UNITED STATES PATENT AND TRADEMARK OFFICE

Office Action Summary

10/753,449

DETAILED ACTION

FIG. 5

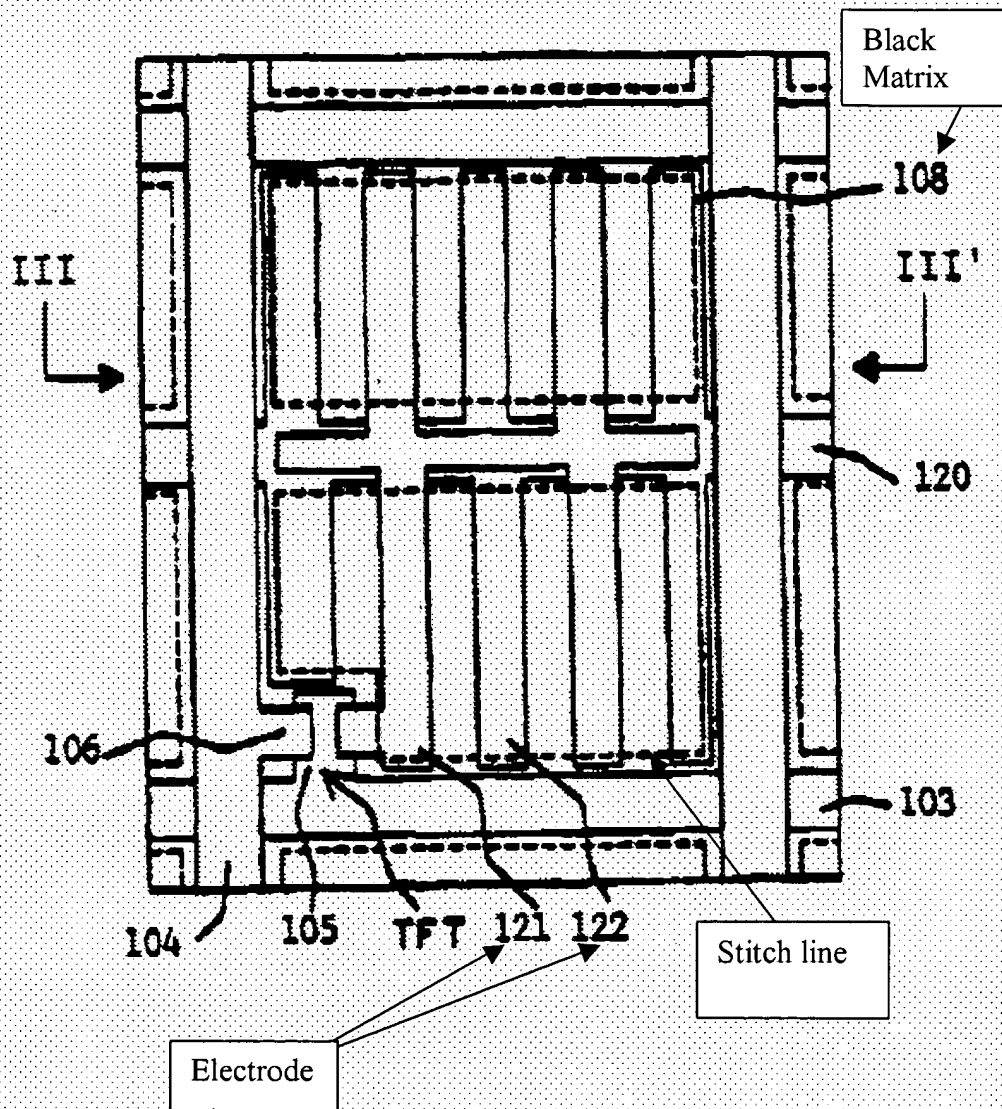
Oh shows **Claim 7**, as a liquid crystal display device comprising: first and second substrates facing into each other (Item 101&102, respectively column 4, line 52-53); a gate line (Abstract, column 5, line 6-7) on the first substrate; a gate insulating layer (item 111) on the first substrate including the gate line; an active layer (item 114a) on the gate insulating layer, a data line (item 104) over the active layer, a passivation layer (item 113) on the data line (Fig. 7, item 101, 104, 111, 114 and 122, column 4, line 7 through 22); a pixel electrode (item 121 & 122) on the gate insulating layer and having a stitch line therein (* See below for explanation of stitch line and pixel electrode); a black matrix (item 108) over the second substrate, wherein the stitch line in the pixel electrode substantially overlaps the black matrix in a vertical direction: (**Fig. 1, 2 and 5, column 2, line 64 through 67, column 3, line 1 through 9, column 1, line 32 through 46**).

* The examiner takes the position that Oh inherently shows the pixel electrode having the stitch line being present therein. The examiner notes that terminology used by the applicant and the prior art are different. While the prior art fails to explicitly label the "stitch area", it is nevertheless implicitly present. The drawing below, taken from Oh, clearly shows the "stitch area" exhibited by the conventional prior art. The stitch line is conventionally known to be present in this type of device. Also, the applicant has referred to a "pixel electrode" over the pixel area. It is believed by the examiner that the present common electrode (item 122) and data electrode (item 121) used in the prior art serve for the same functionality; to supply an electric field over the pixel area. Therefore figure #5 shows a pixel electrode on the gate insulating layer and having a stitch line therein.
